Converting a Bottom-fed 6813-4 Antenna into a Center-fed 6813-8

This tech sheet describes the field addition of four bays to a bottom-fed 6813 four-bay antenna so as to convert it into a center-fed 6813 eight-bay. Follow these instructions carefully to ensure successful conversion.

Document No. ts-6813_4bay_to_8bay (0611)

Figure 1. Antenna Assembly Before Conversion (shaded indicates parts removed)

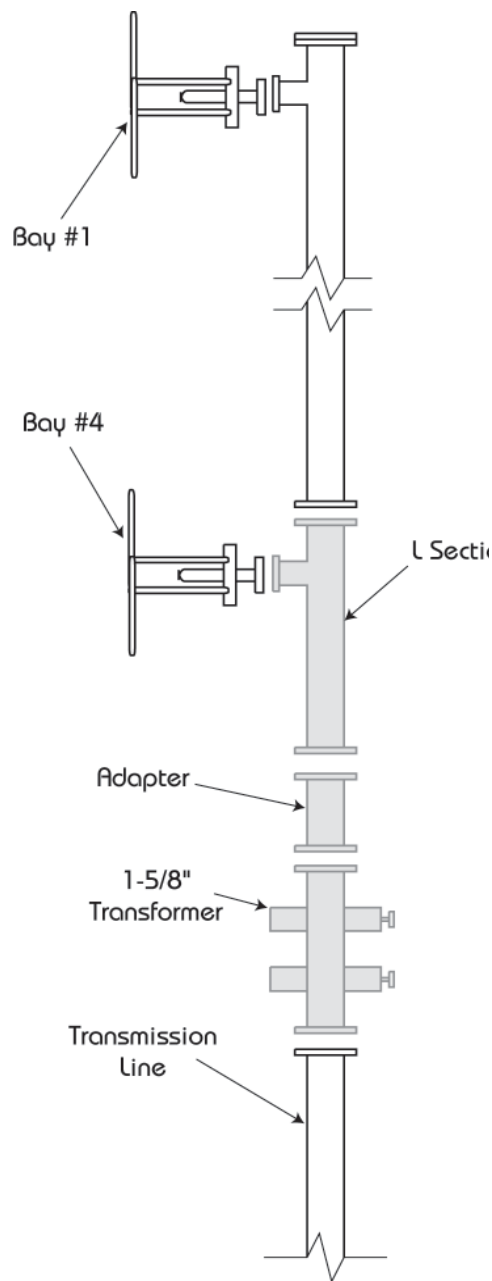
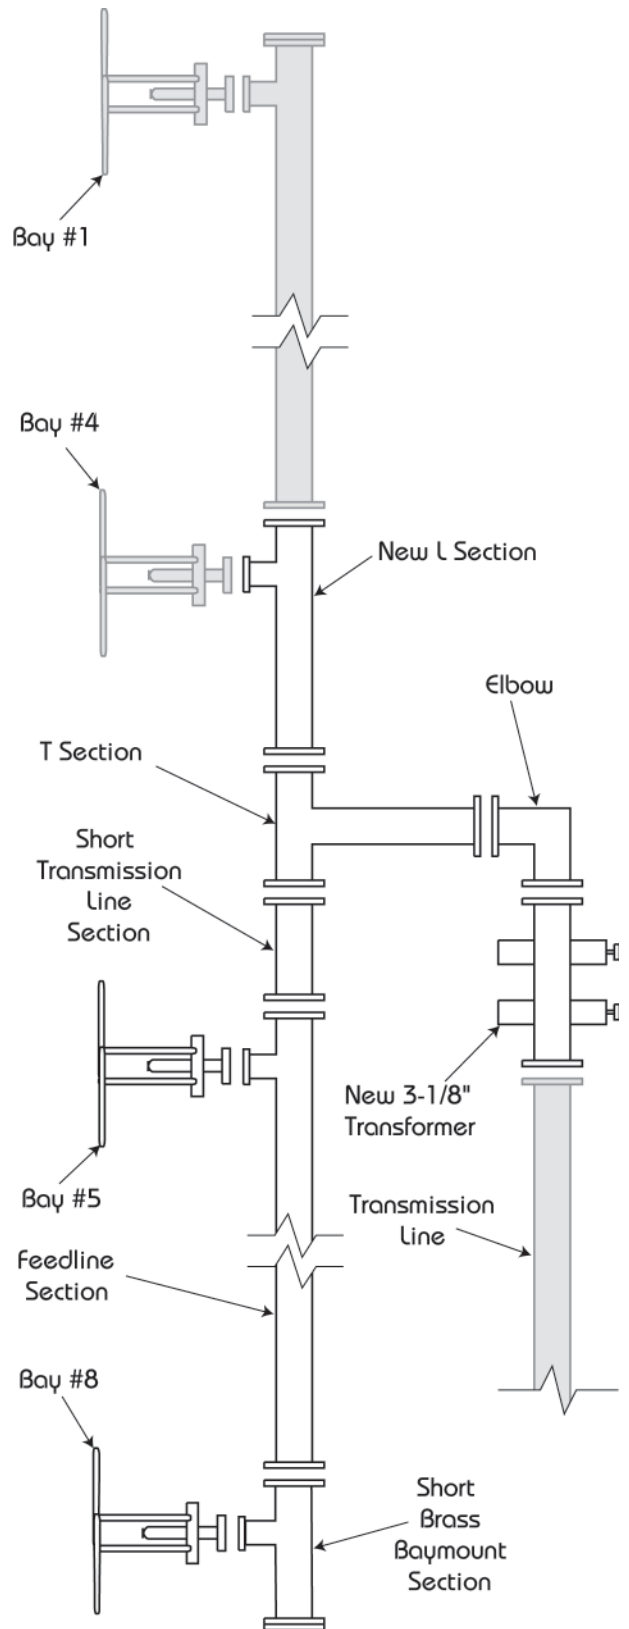
Figure 1 shows the antenna before the conversion; figure 2 shows it after the conversion. See also the enclosed owner's manual if applicable; it describes radome installation, deicer wiring, and other information you may need.

- Turn off the transmitter and the deicer, if applicable, and tag and lock them out on the ground, to prevent their being turned back on inadvertently.
- Remove antenna bay #4 (the lowest one) from its L section. You may have to remove the radome to remove the antenna bay. Save the bay for reinstallation.
- Remove the L section and discard it.
- Remove the transformer and store or discard it.

- Install the new L section provided with the conversion kit.
- Reinstall the bay you removed in step 2 onto the new L section. Reinstall the radome if applicable.
- Install the T section at the bottom of the L section, with the long arm extending toward what will be the transmission line attachment point.

- Install the short transmission line section at the bottom of the T section.
- Install the feedline sections provided with the kit at the bottom of the short transmission line section.

- j. Install the short brass baymount section at the bottom of the feedline section installed in step 9.
- k. Install antenna bays #5, 6, 7, and 8 on the feedline section installed in step 9.
- l. Install the transmission line elbow provided with the kit onto the horizontal end of the T section installed in step 7.
- m. Install the new 3-1/8" transformer at the bottom of the elbow.
- n. Connect the transmission line to the bottom of the transformer. Additional parts may be required to match the transmission line to the new attachment point; this is your responsibility.
- o. Reconnect the deicer system if applicable.
- p. Start the antenna up in accordance with Chapter 2 of the owner's manual. Follow all precautions. Be sure to perform all tests to ensure the antenna is operating properly before releasing it for service.
